HYUNDAI Technical Service Bulletin

GROUP BODY ELECTRICAL	NUMBER 26-BE-010H
DATE APRIL 2026	MODEL(S) SEE BELOW

SUBJECT: INOPERATIVE HORN ASSEMBLY REPLACEMENT
(WARRANTY EXTENSION Z07)

High-Pitch Horn Assembly: Kona N (OS N)

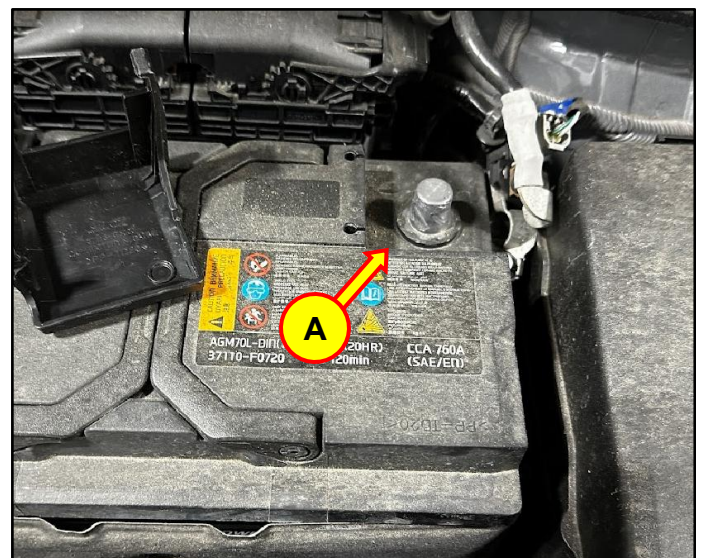
NOTE: The high-pitch horn will remain in its horizontally mounted orientation.

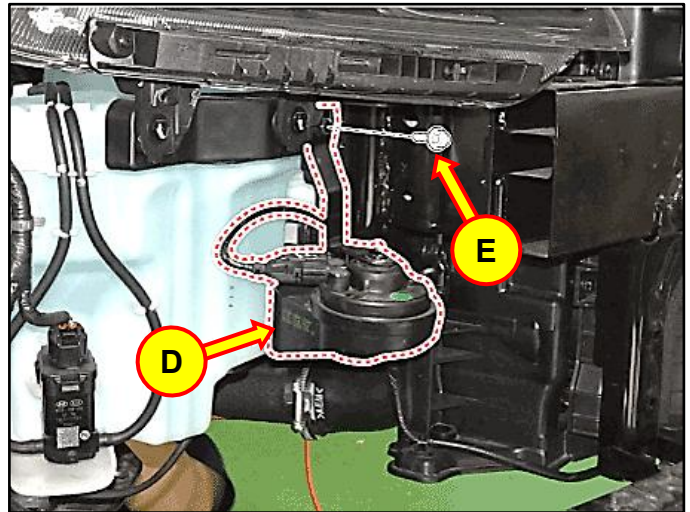
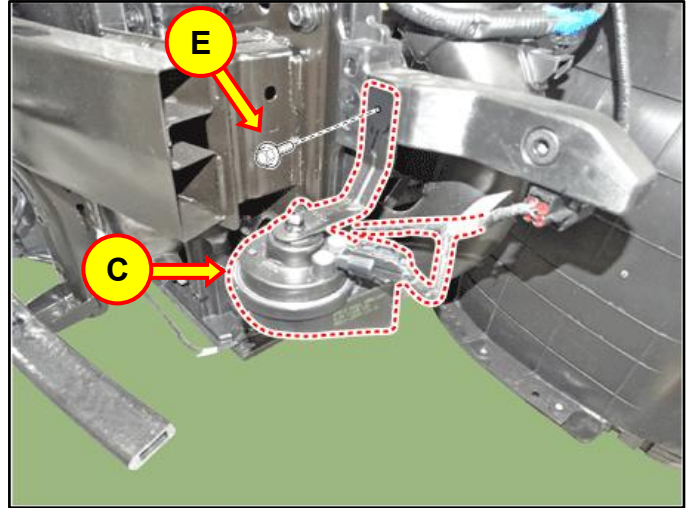
- Remove horn(s) (C, D) by disconnecting the horn connector and removing the mounting bolt (E).

The low-pitch horn is now mounted vertically instead of horizontally. The high-pitch horn remains in its original horizontal position.
